# Access Compliance Report

## Public Rights-of-Way

### (Curb Ramps)

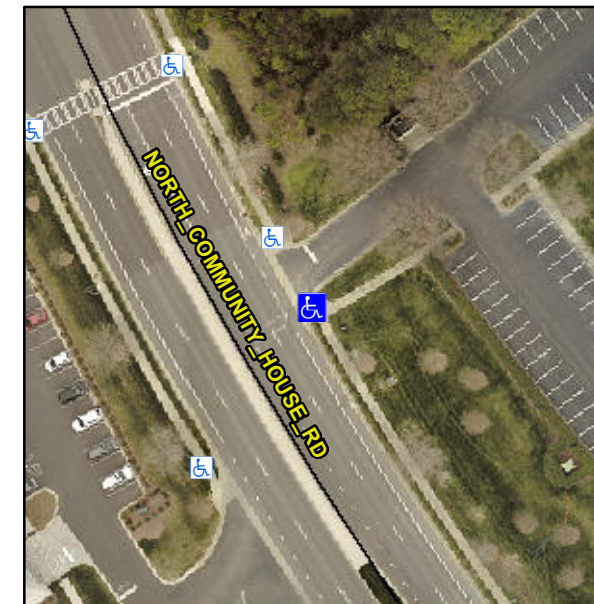
**Not Found, R304.5.3**

Compliance	Description	Data	Compliance	Description	Data
N/A	Ramp Length (in)	146.0	Yes	Ramp Slope (%)	5.1
Yes	Ramp Width (in)	57.0	No	Ramp XSlope (%)	5.4
N/A	Flare Type LT	N/A	N/A	Flare Type RT	N/A
N/A	Flare Slope LT (%)	N/A	N/A	Flare Slope RT (%)	N/A
N/A	Flare Traversable LT?	N/A	N/A	Flare Traversable RT?	N/A
N/A	Landing Length (in)	N/A	N/A	DWS Provided?	N/A
N/A	Landing Width (in)	N/A	N/A	DWS Contrast?	N/A
N/A	Landing Slope (%)	N/A	N/A	DWS Length (in)	N/A
N/A	Landing X Slope (%)	N/A	N/A	DWS Full Width?	N/A
N/A	Landing Curb? (Y/N)	N/A	N/A	DWS Offset (in)	N/A
N/A	Shared Landing?	N/A			
N/A	Gutter Ponding?	N/A	N/A	Gutter Slope (%)	N/A
N/A	Gutter Lip Ht (in)	N/A	N/A	Gutter X Slope (%)	N/A
N/A	Painted X Walk1?	No	N/A	Painted X Walk2?	N/A
	X Walk 1 Direction	To NW		X Walk 2 Direction	N/A
N/A	X Walk 1 Width (in)	N/A	N/A	X Walk 2 Width (in)	N/A
	X Walk 1 Slope (%)	2.7		X Walk 2 Slope (%)	N/A
	X Walk 1 X Slope (%)	1.8		X Walk 2 X Slope (%)	N/A

**Remove & Replace Entire Ramp.**
